Illustrated Parts List - IPL Update

H572XP/XPG

1. Carburettor area base, kit

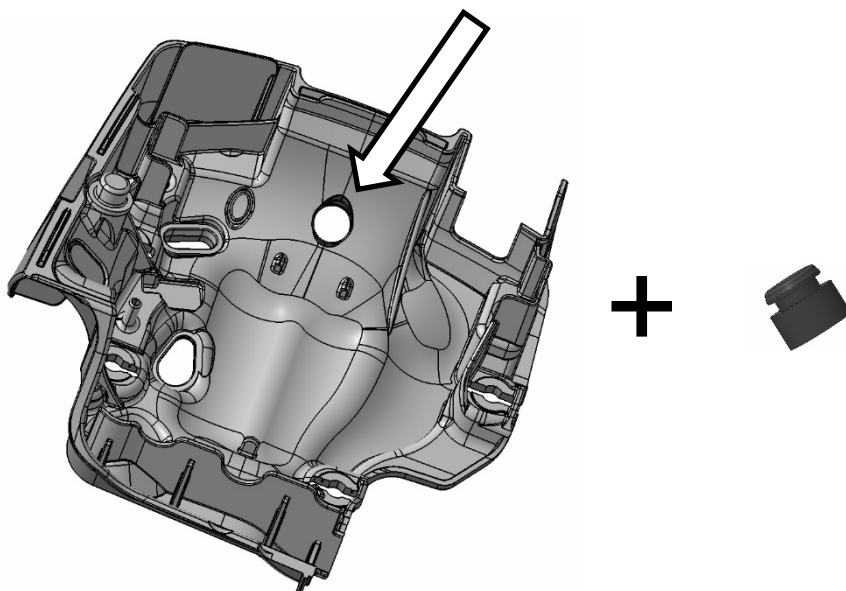
1. We have a new Carburettor area base, kit 534 11 41-01, for improved durability. The kit consist of new Carburettor area base and Support 501 51 54-01.
2. We have implemented a new reinforced Oil Pump Assy, 589 02 84-03. New Oil pump has a **Natural** sealing plug.
